# HISTORIC PRESERVATION COMMISSION

# **MEMORANDUM**

SUBJECT: Historic Area Work Permit # 978966: Installation of new telecommunications equipment

The Montgomery County Historic Preservation Commission (HPC) has reviewed the attached application for a Historic Area Work Permit (HAWP). This application was **Approved with one (1) condition** at the February 16, 2022 HPC meeting.

**ANTENNA PLAN** & NOTES

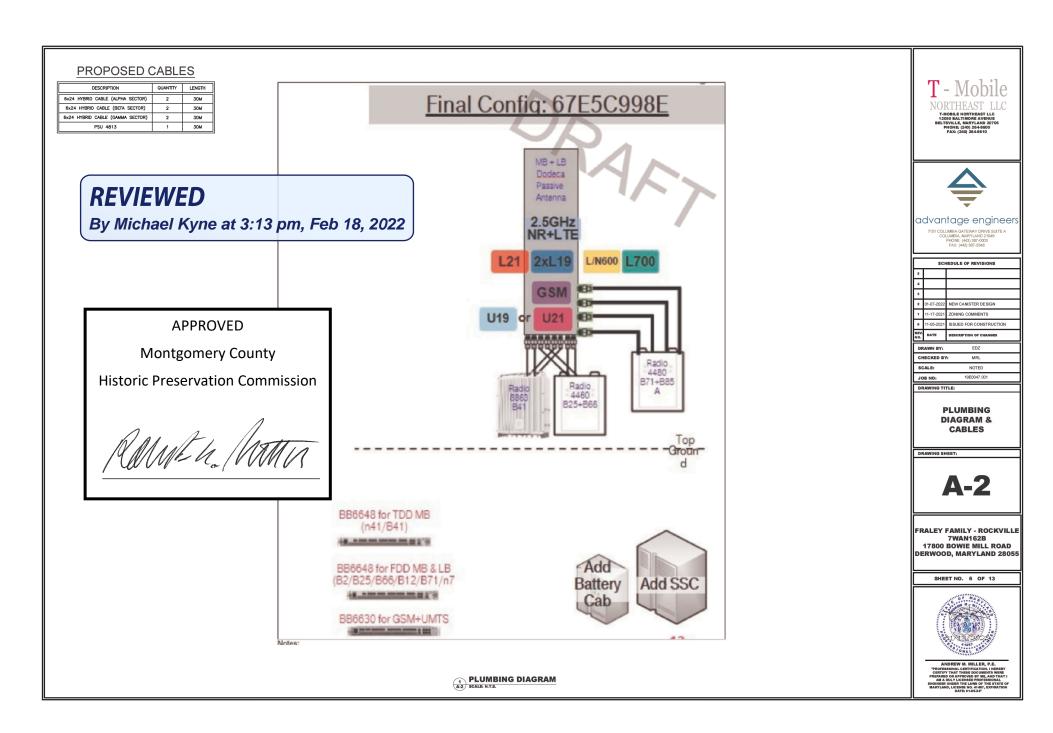
1. The proposed new RF Friendly Canister will be painted matte blue, with final review and approval delegated to staff.
